FRAMING ADDENDUM

SAB HOMES

RE: REDBUD PLAN (HF02)
2034 SW FARMFIELD LANE
LEE'S SUMMIT, MO.

HIP/VAL OVER CUT SEAT REINFORCING DETAIL

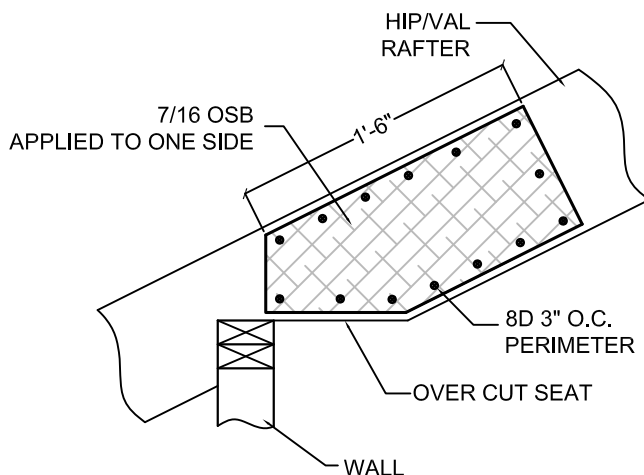
-Address notched valley rafter and bearing

There are several locations where the hip and valley seat cuts are in need of additional reinforcing to ensure proper transfer of roof loads. The hip/valley rafters will be reinforced with a layer of 7/16 OSB attached as shown in the detail below.
